STREETSCAPE AND DECK-OVER PROJECT

FROM NORTH OF DUPONT CIRCLE TO CALIFORNIA STREET NW

Project Update *November 2021*

January 2021 Design

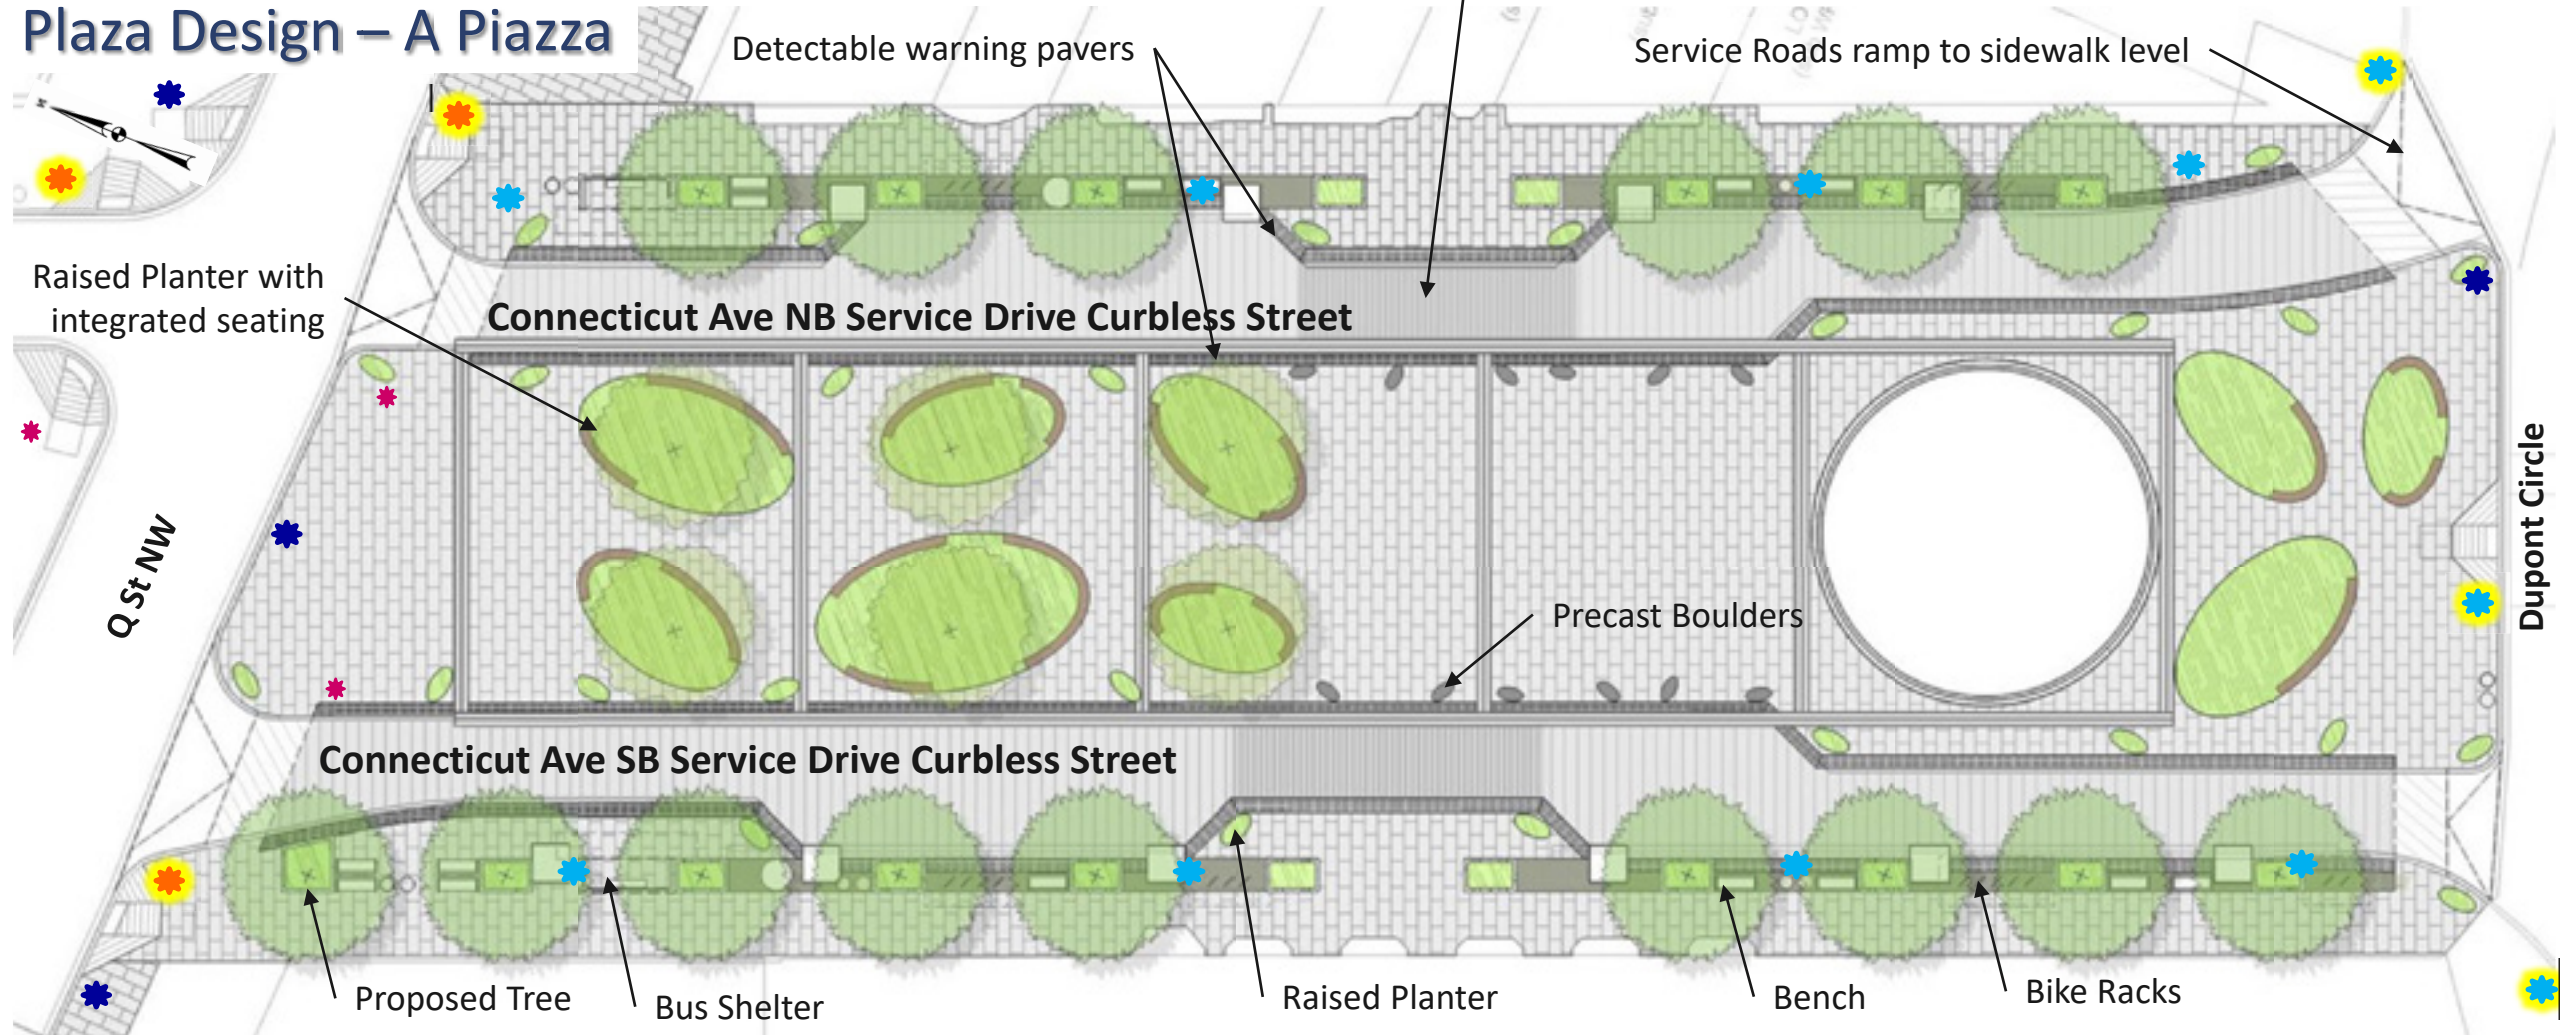
Plaza Comments

- Encouraged continuous street tree placement along plaza
- Regular placement of the honey locusts in planters
- Supported oval plants and playfulness of varying sizes
- Recommended stone in place of precast concrete boulders or use of more regular and substantial design element to avoid future installation of supplemental barriers
